Figure 2
Project Boundary
Modification
Nobles Repower Project
Nobles County, Minnesota

December 2, 2020

Subject: DNR Early Coordination Comments for Nobles Wind Repower

Figure 3
Wind Access Buffer
Setbacks
Nobles Repower Project
Nobles County, Minnesota

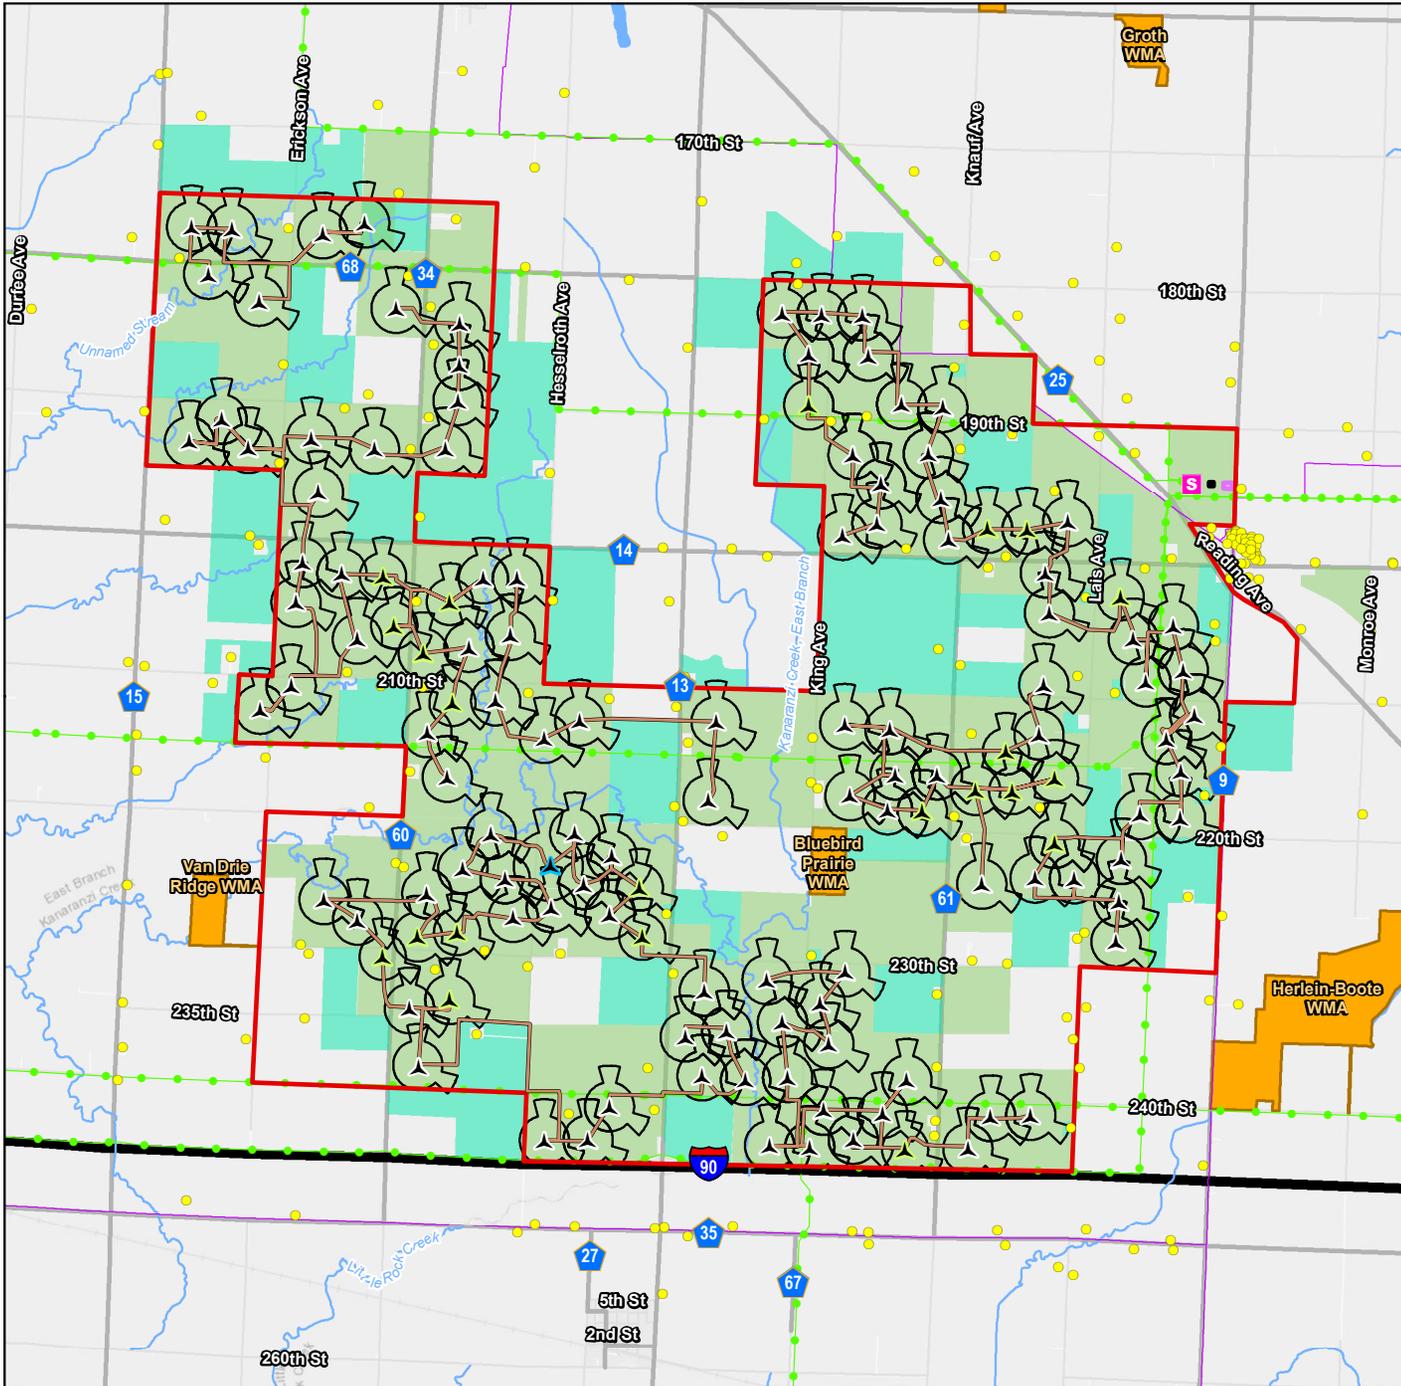
The Public Utilities Commission (PUC) protects non-participating landowners through the wind access buffer of 5 rotor diameters (prevailing wind direction) and 3 rotor diameters (non-prevailing wind direction). The only public land identified within the project footprint is Blue Bird WMA (Herlein-Boote and Van Drie Ridge WMAs are just outside of the project footprint area). At about 0.2 miles to the closest turbine, we are not identifying any issues with this setback in regards to State owned lands, but ensure this requirement is met for private lands as well.

Figure 4
Project Area and
Facilities

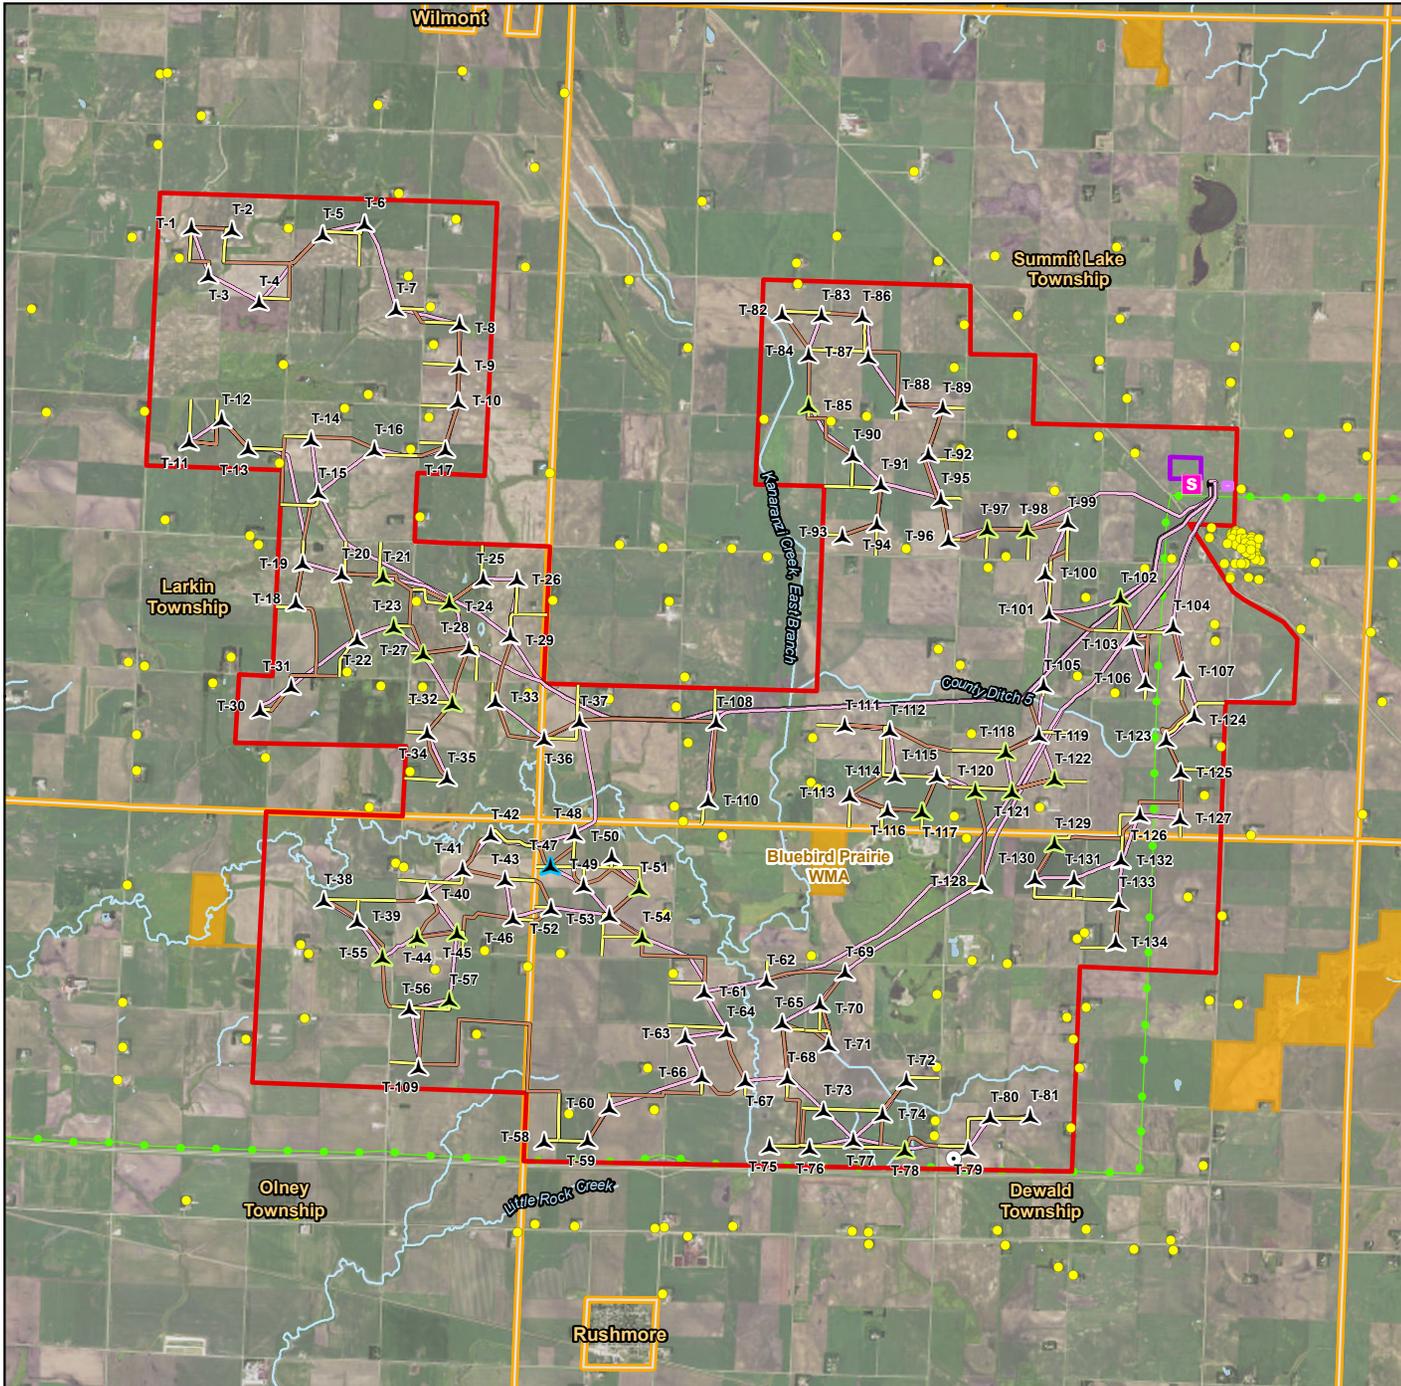
Several natural resources (i.e. native plants, sites of biodiversity significance, mussels, Topeka shiners, other Species in Greatest Conservation Need) have been identified adjacent to the East Branch of Kanaranzi Creek. Overall, the proposed project crane paths seem to consider this and other resource-rich areas within the project boundary. However, some areas (e.g. crane path between towers 61 and 62 adjacent native plant communities) appear to come excessively close to high value resources despite an adjacent road. We recommend that wherever possible, any resources are avoided by using already established roads or access roads.
